Construction Industry Coalition on Water Quality

September 14, 2015

RE: Comment - Tentative Order No. R9-2015-0100, Place ID: 686088WChiu

Photo 1 – La Jolla Landslide (Ardath Shale Formation, Claystone, Hydrologic Group D)

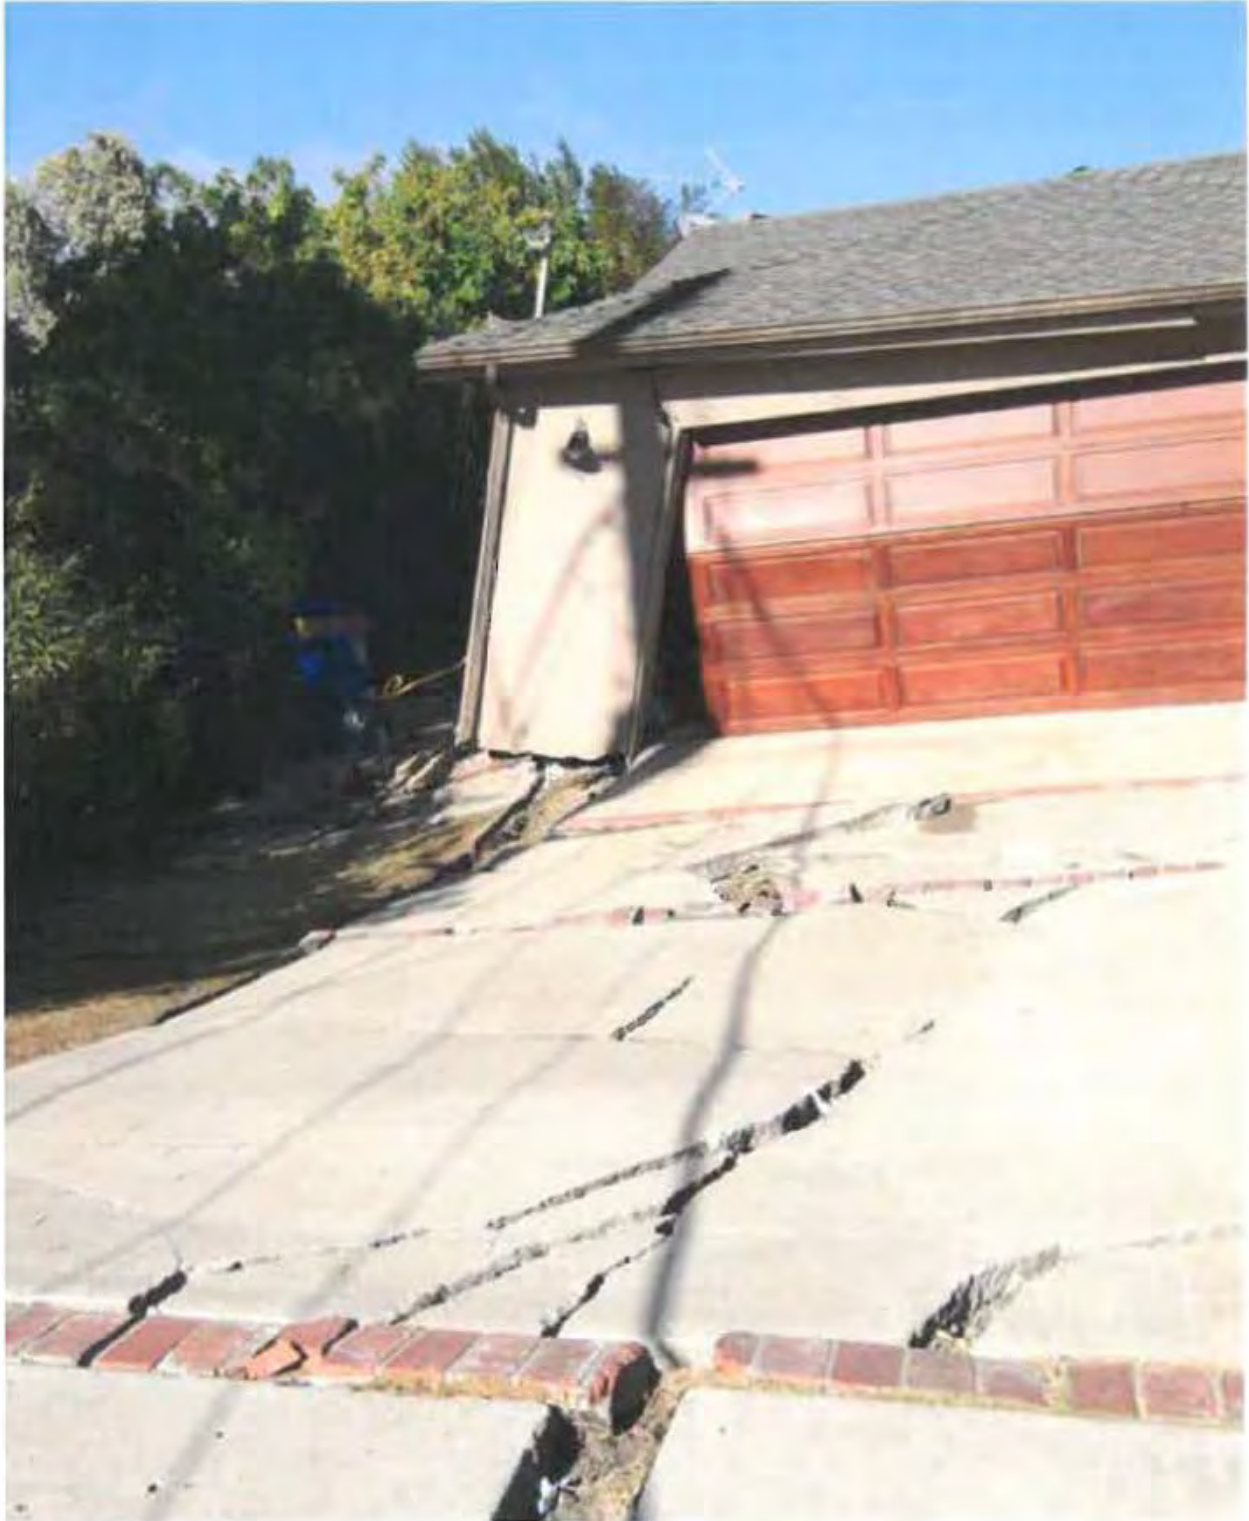
The soil types in Region 9, and particularly San Diego County, are likely infeasible for infiltration where stormwater could eventually reach the underground aquifer. More than 70 percent of the soil types found in San Diego County possess a Soil Hydrologic Group classification of C and D (USDA, 1973). A large majority of the land area possesses a classification of C or D (SANDAG, 2007) and soft/hard rock (CGS, 2007). Using infiltration as a preferred method of stormwater remediation county-wide, therefore, is unsupported. Clearly stated, in the appropriate soil type, infiltration is a preferred alternative. In the wrong soil type the results could be catastrophic. (See photos 1 & 2).

Photo 7 mid-rise condo project at the NW corner of 4th and Nutmeg, San Diego

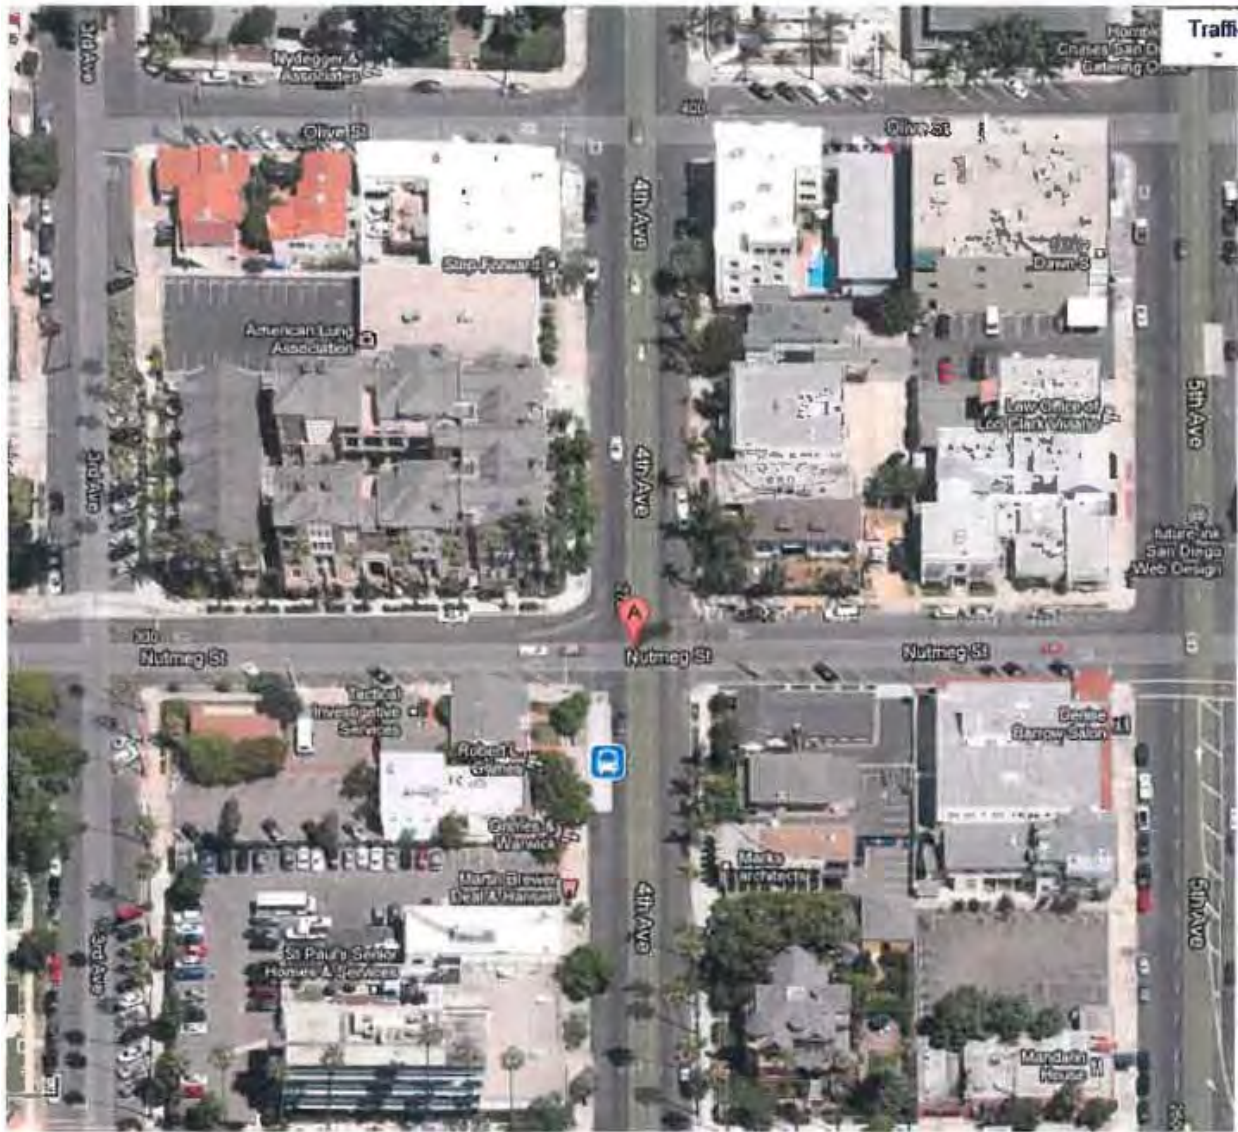
hydromodification exemptions on infill development render these projects both technically and financially infeasible. (Refer to photograph 7.)

Photo 7 shows a smart growth project on the northwest corner of 4th & Nutmeg in San Diego's highly urbanized Banker's Hill neighborhood: transit friendly (transit oriented development, TOD); walkable neighborhood; near parks, shopping and recreation (2 blocks from Balboa Park); near San Diego's airport; near Downtown/Hillcrest/Mission Valley work environments; and within the Smart Car (car 2 go) user footprint. Under the Revised Draft Permit, this project would become infeasible because of the 100% pollutant capture (infiltration/reuse) requirement and the loss of the hydromodification exemption previously included in the HMP.
